Proposed Revisions to a Standard Plans Index

Index Number: 646-001

Index Title: Aluminum Post and Pedestal Mounted
Pedestrian Detectors and Signals

INDEX
646-001

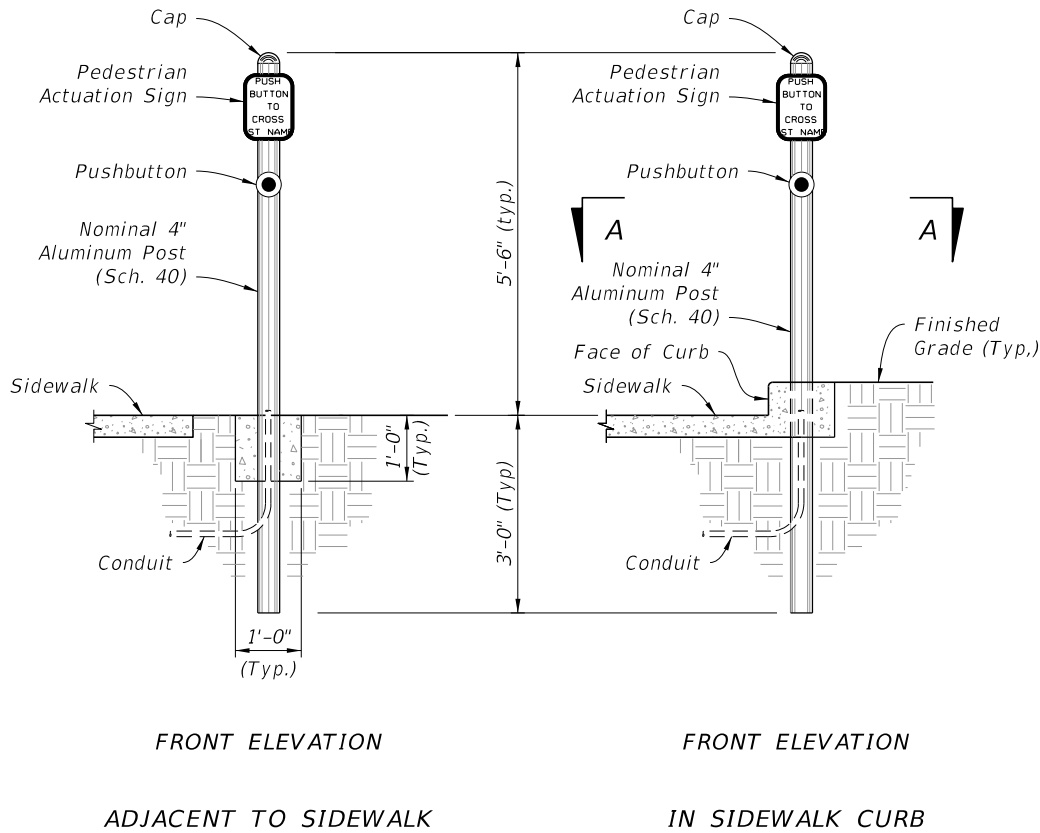
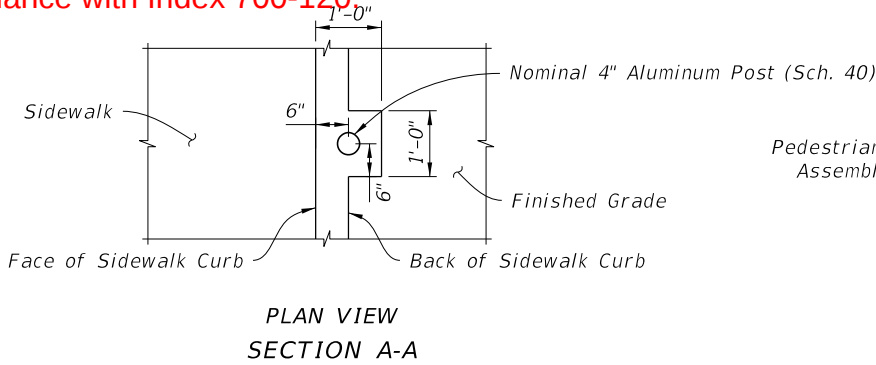
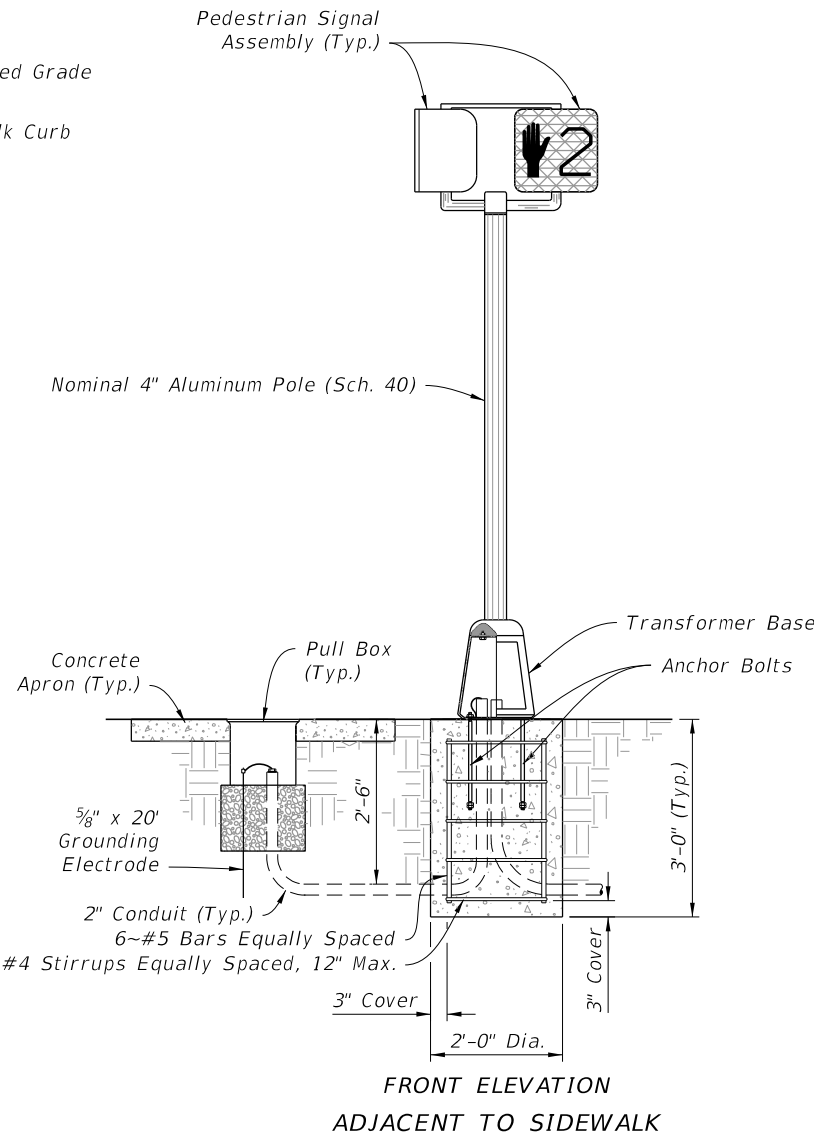
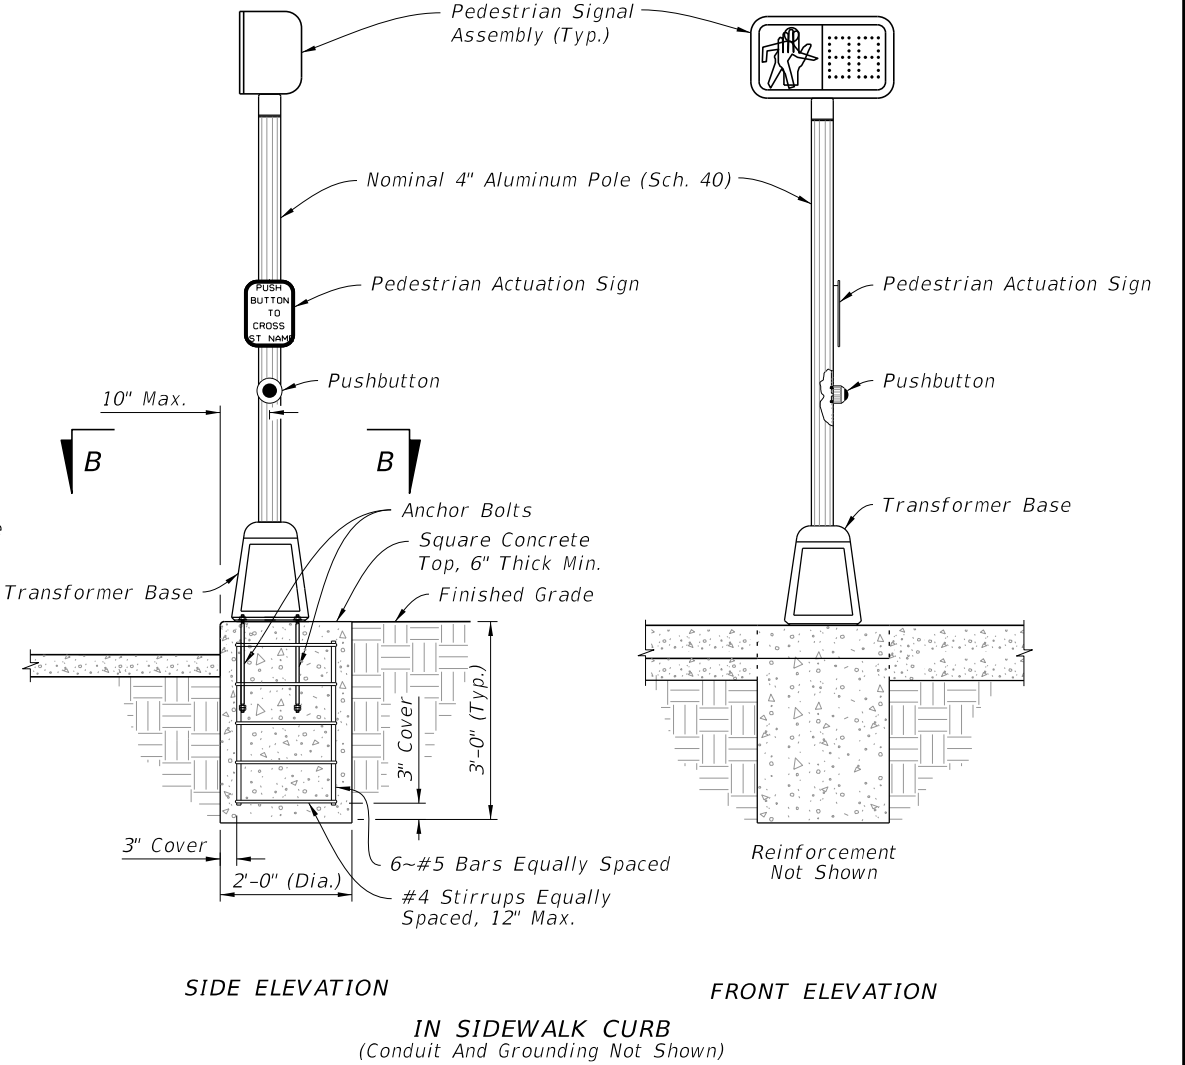
Added Note 6, "In lieu of footing design shown, a Spread Footing may be used in accordance with index 700-120."

Note 6 was added because of new spread footing design in Standard Plans Index 700-120.

6. In lieu of footing design shown, a Spread Footing may be used in accordance with Index 700-120.
